### APPEAL SUMMARY

<b>Appeal ID:</b> 22216	<b>Project Address:</b> 222 SW Clay St
<b>Hearing Date:</b> 12/11/19	<b>Appellant Name:</b> Nancy I Strening
<b>Case No.:</b> M-002	<b>Appellant Phone:</b> 5037059768
<b>Appeal Type:</b> Mechanical	<b>Plans Examiner/Inspector:</b> Jeff Donnelly, Thomas Ng
<b>Project Type:</b> commercial	<b>Stories:</b> 7 <b>Occupancy:</b> A-1 <b>Construction Type:</b>
<b>Building/Business Name:</b> Keller Auditorium	<b>Fire Sprinklers:</b> Yes -
<b>Appeal Involves:</b> Reconsideration of appeal	<b>LUR or Permit Application No.:</b>
<b>Plan Submitted Option:</b> pdf [File 1] [File 2] [File 3] <b>Proposed use:</b> Performing Arts

**Code Section** OEESC 503.4.1

**Increase in cooling capacity with omission of required economizer: Granted as proposed.**

1 MECHANICAL BACKSTAGE SECTION LOOKING EAST  
MS4.02 SCALE: 3/32" = 1'-0"

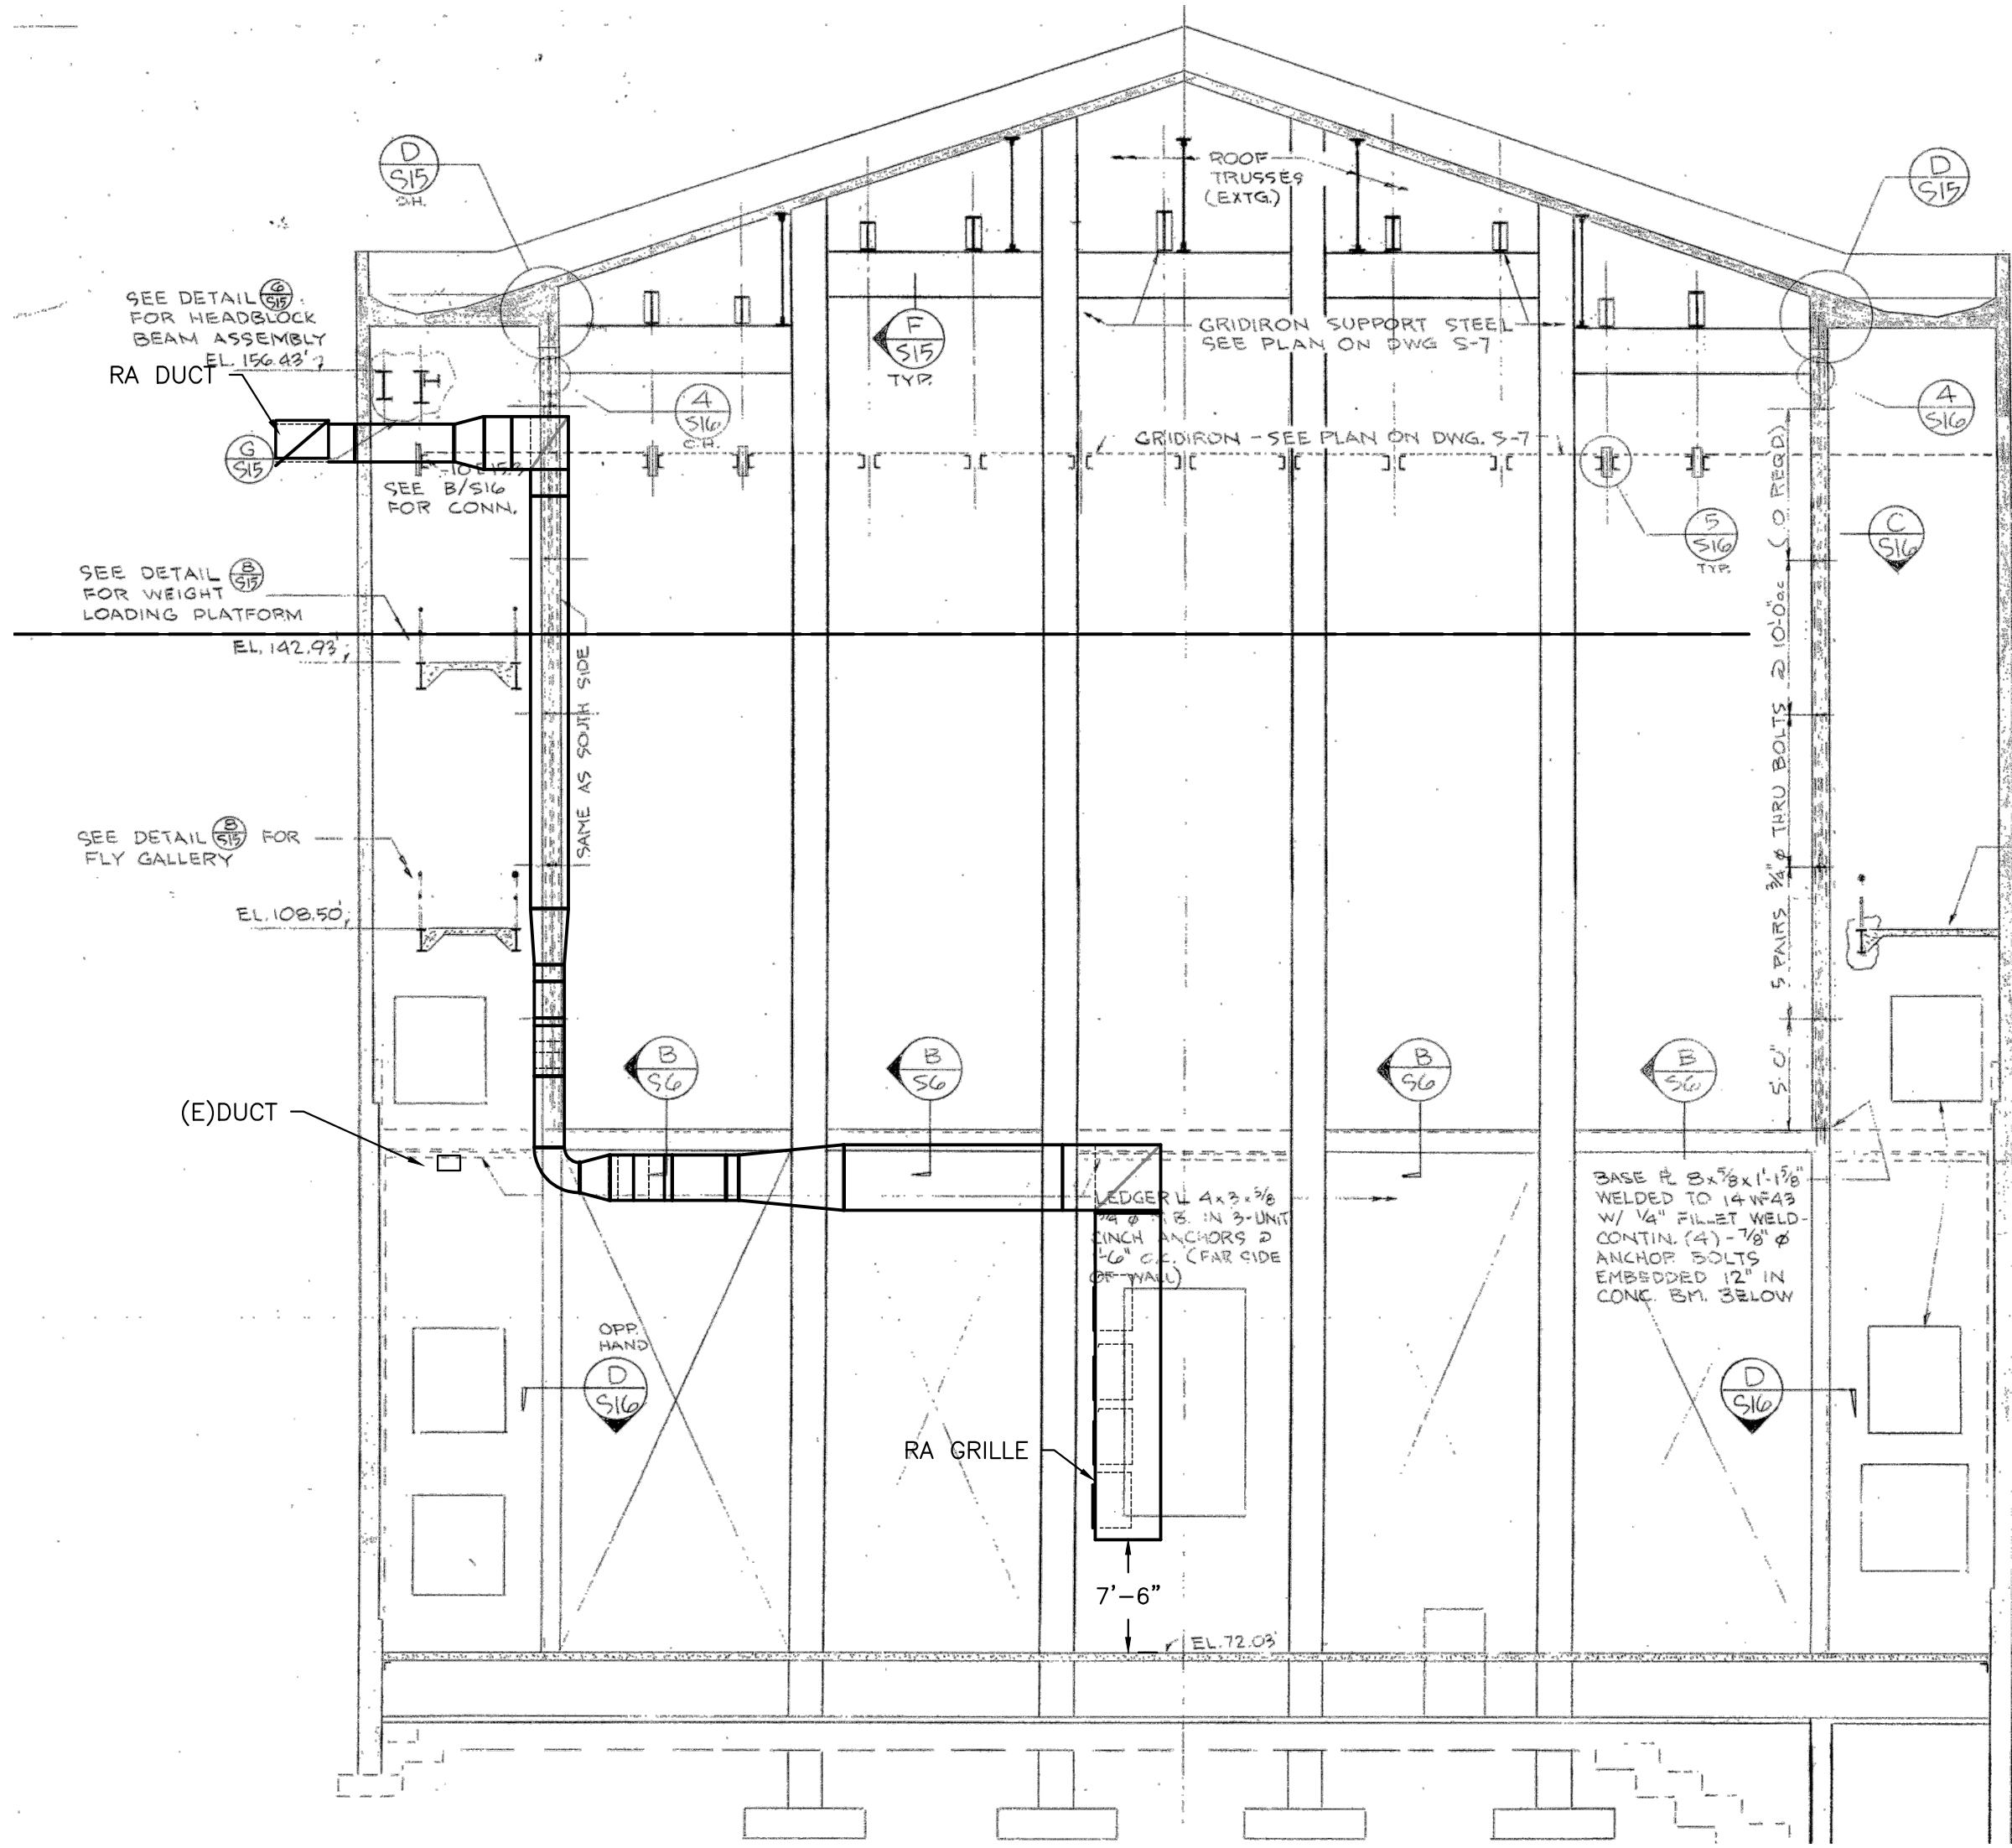
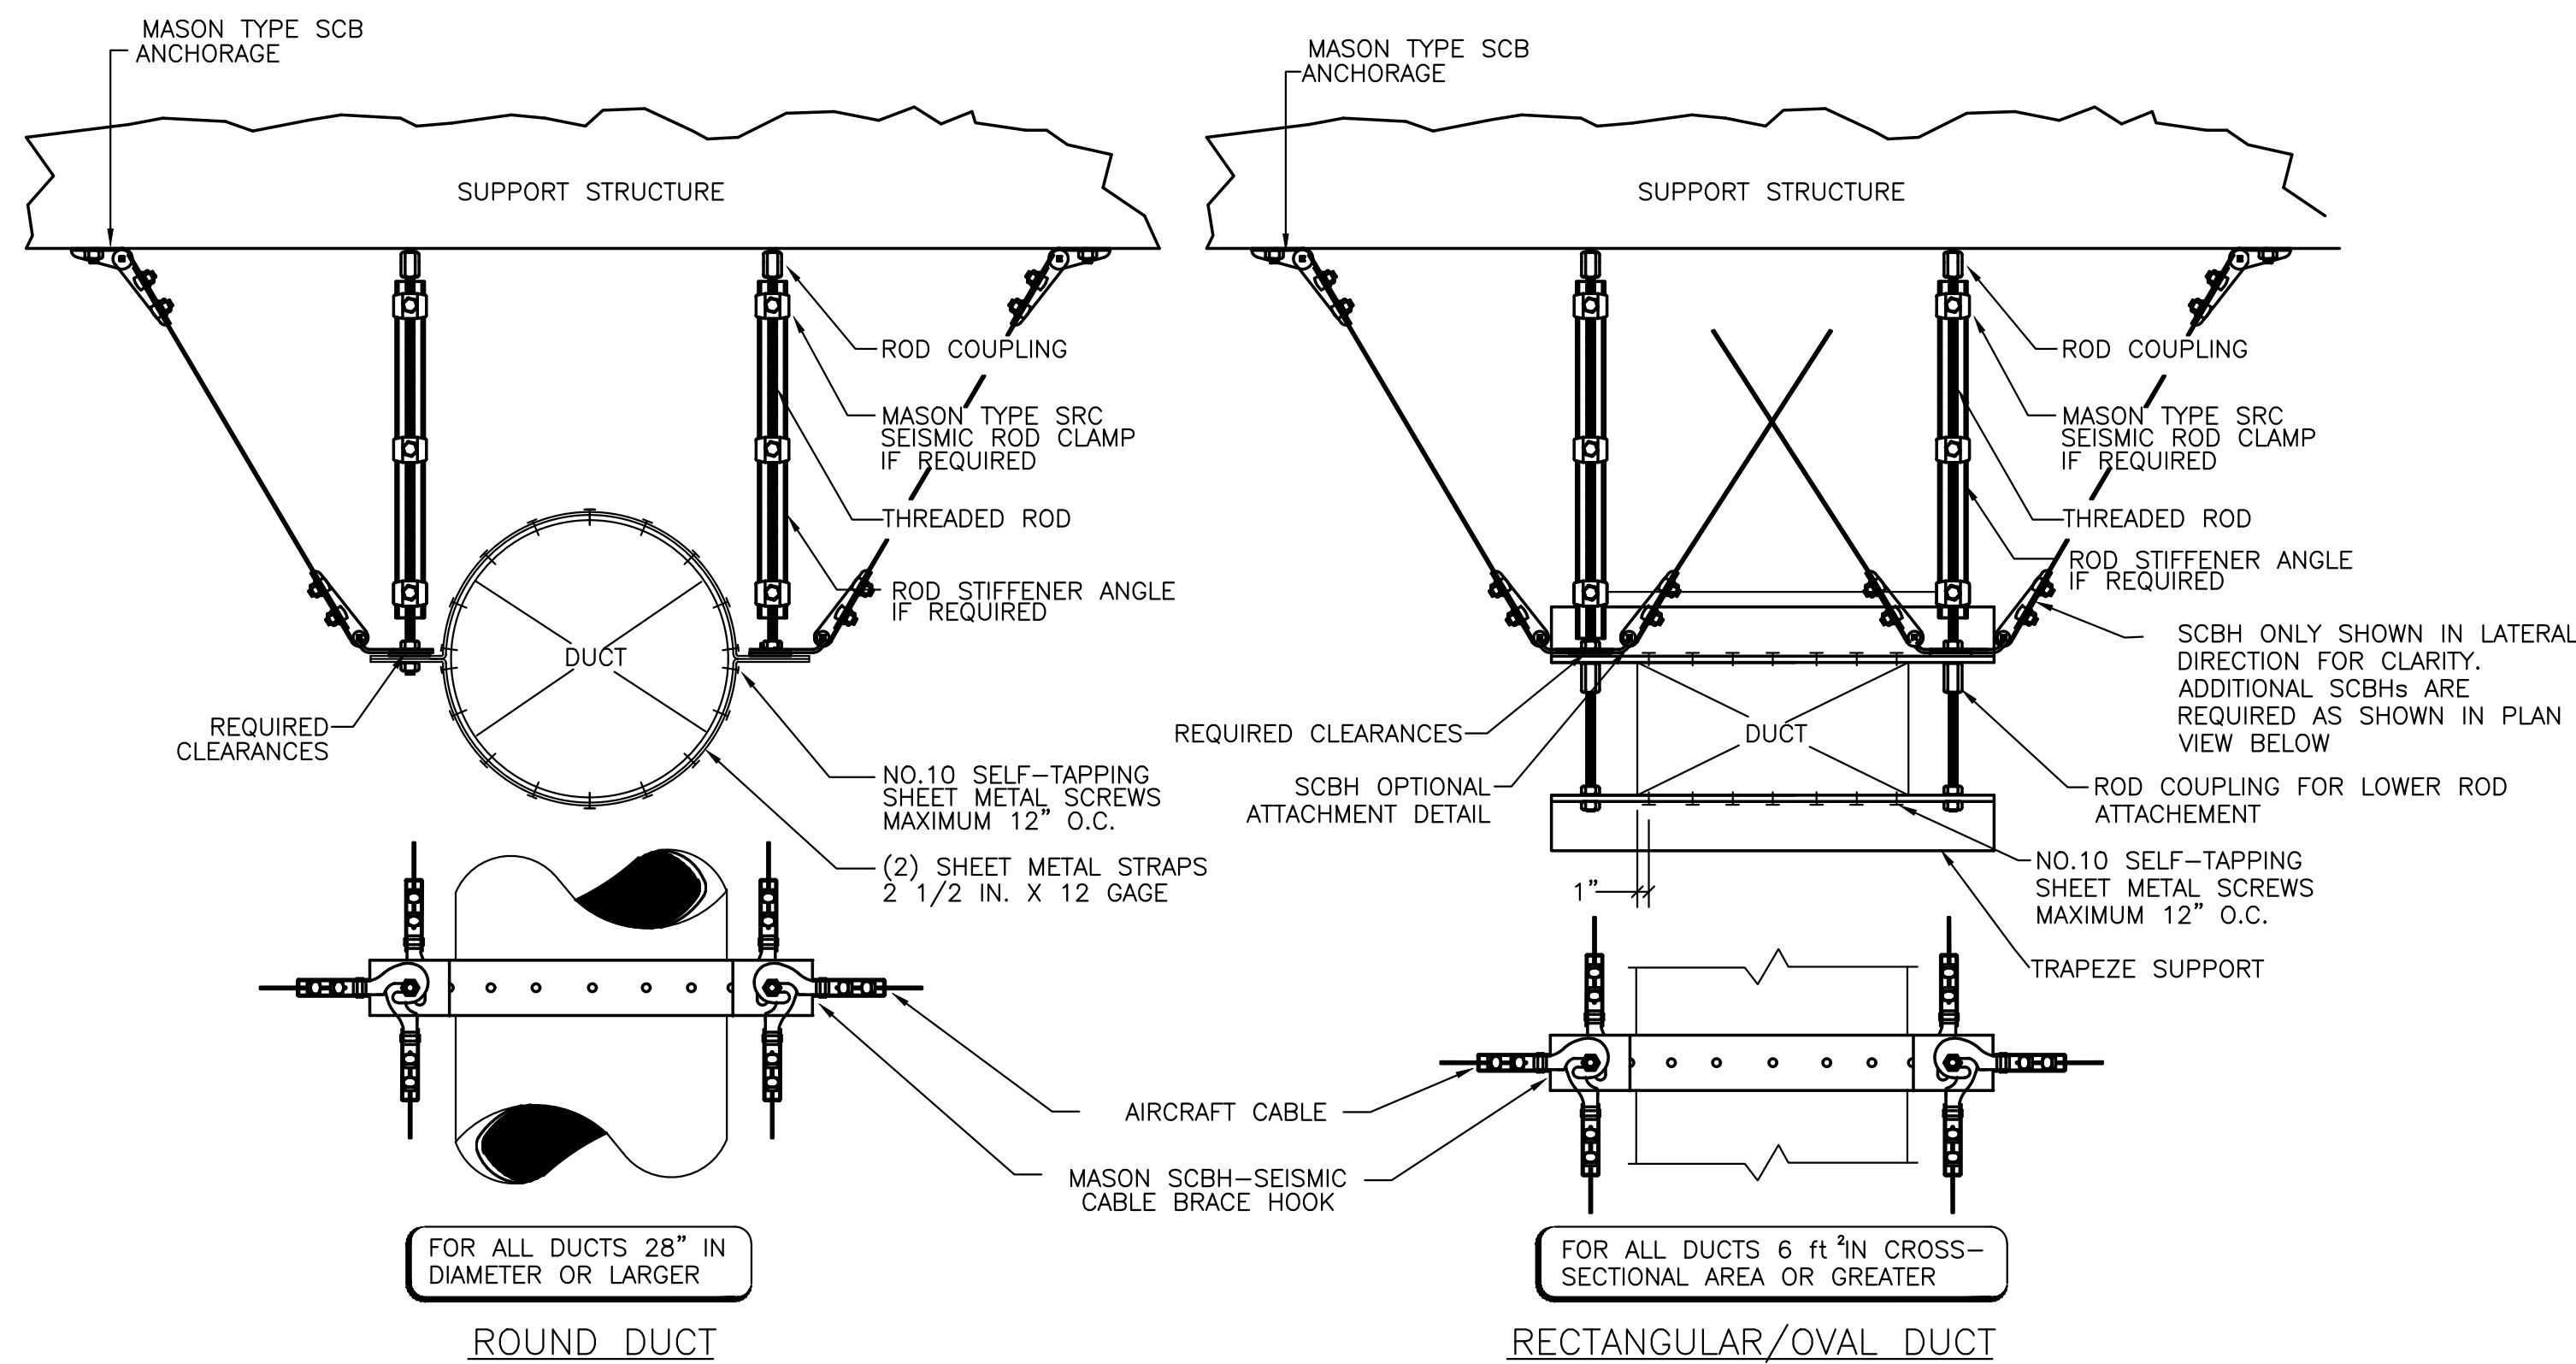
The 7/25/2019 Design drawings (refer specifically to Sheets MS2.09, MS4.01, & MS4.02) call for structural modifications to the roof deck to accommodate the roof-mounted units. Please refer to attached letter dated 10/15/2015 from Metro cPMO Manager to Portland Center's for the Performing Arts Director outlining the barriers to determining additional structural capacity of the Keller Auditorium Roof. Although the 2015 letter was in relation to the roof replacement project initiated the following year, the challenge exists for this stage cooling project: It is impractical to determine additional structural capability of the roof, therefore roof-mounted units are not an option.

Refer to sheets MS4.01 & MS4.02 of the 7/25/2019 Keller Auditorium Stage Cooling drawings by MFIA, Inc. Engineers for the location/configuration of the ductwork required by the roof top unit solution. This design configuration would require a lengthy and expensive Type II Land Use review and it is unlikely that Metro would receive approval to place ductwork on the exterior of the building.

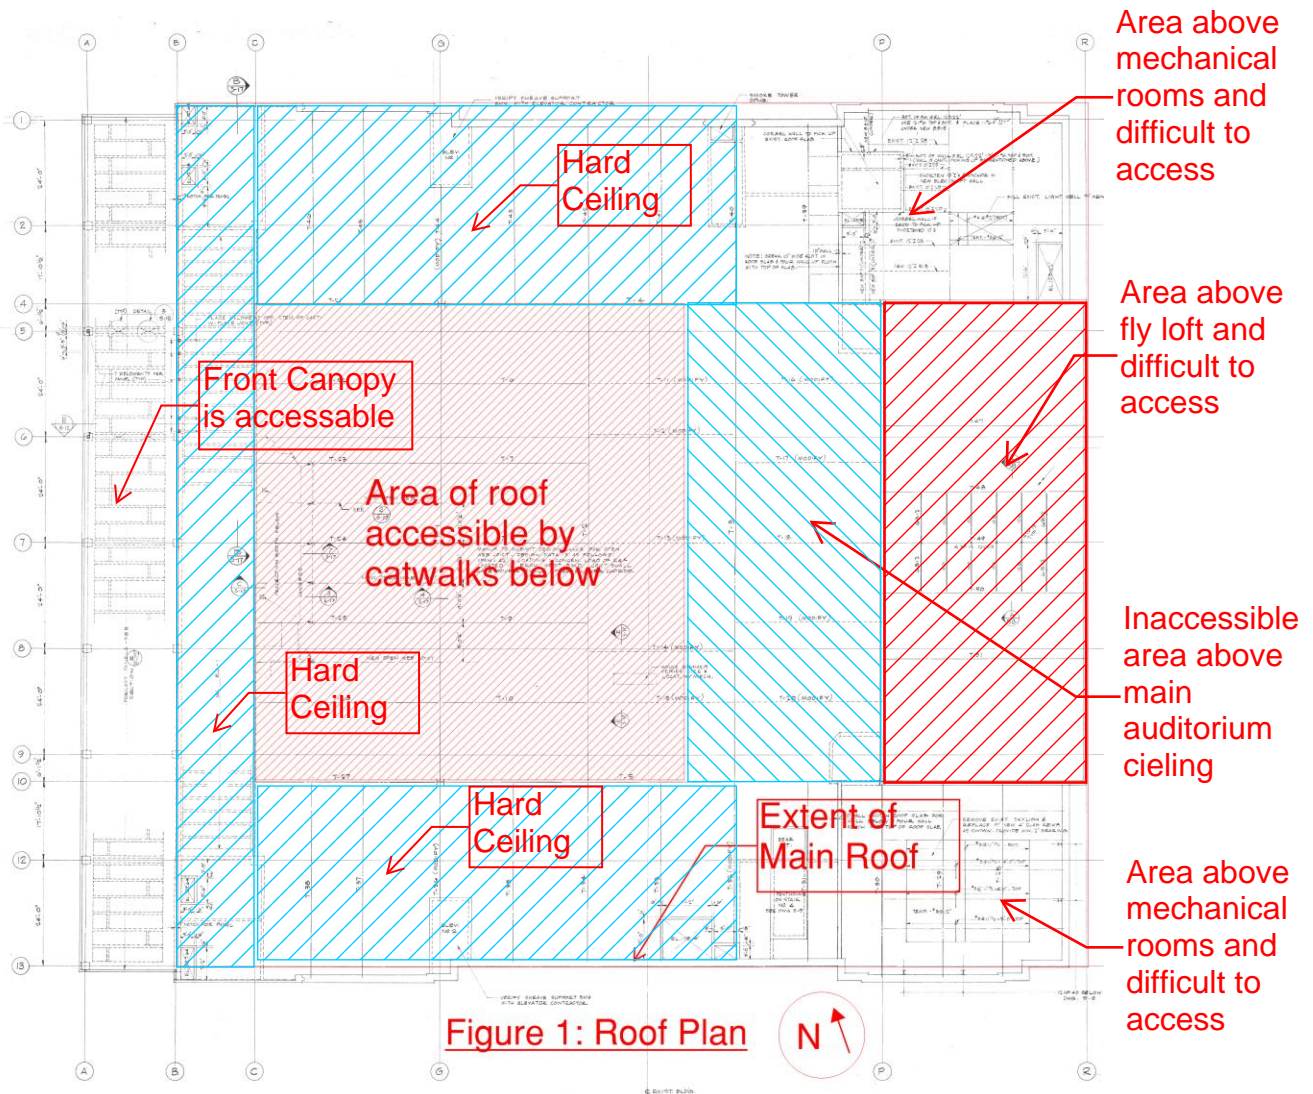
4. The catwalks above the ceiling only allow access to approximately one fourth of the roof area as shown in Figure 1 below. The remainder of the roof area is not easily accessible. Without additional access, the investigation and therefore our analysis on the roof capacity will be incomplete for the majority of the roof.
